Section 62A Planning Application:  
S62A/22/0006 Berden Hall Farm,  
Ginns Road, Berden:  
Representation on Transport and  
Highways Matters on behalf of  
Local Residents

# Railton TPC Ltd

| Date:                      | August 2022                   |

**Figure 3.1: HGV Access Route**

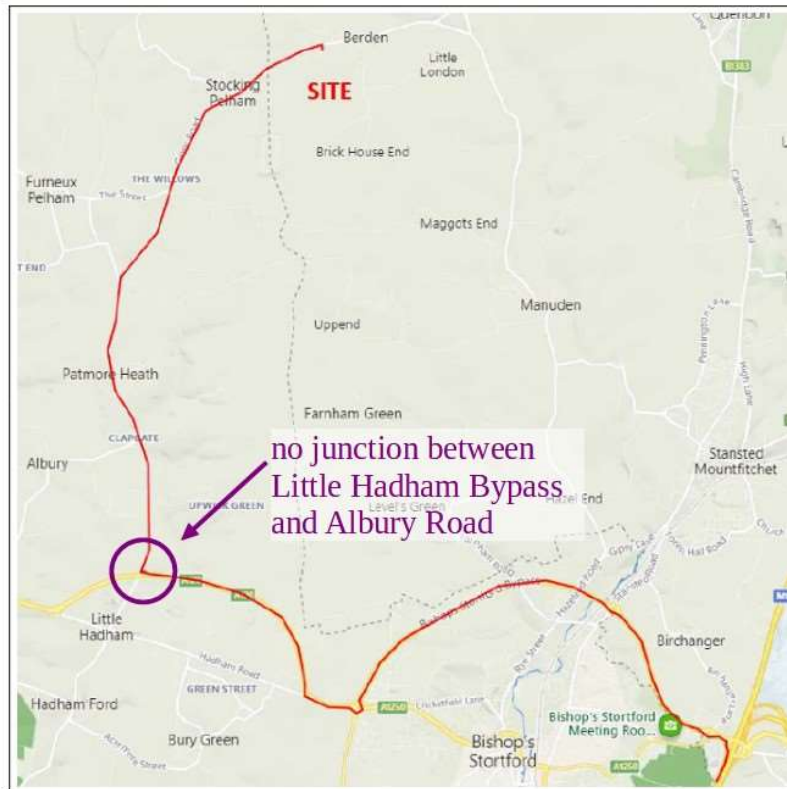
- 3.2 The proposed route is shown to include the Little Hadham Bypass. However, there is no junction between the Little Hadham Bypass and Albury Road. All construction vehicles will therefore be forced to travel through the village of Little Hadham and approach the Albury Road junction in the centre of the village either from the east or from the west.
- 3.3 The Applicant has undertaken no assessments of the sensitivity of Little Hadham to increases in HGV movements or the magnitude of increase in HGV movements during the construction.

- 7.6 The CTMP wrongly assumes that it is possible to access Albury Road directly from the Little Hadham Bypass. This is a fundamental error that is indicative of the cursory nature of the transport supporting work.
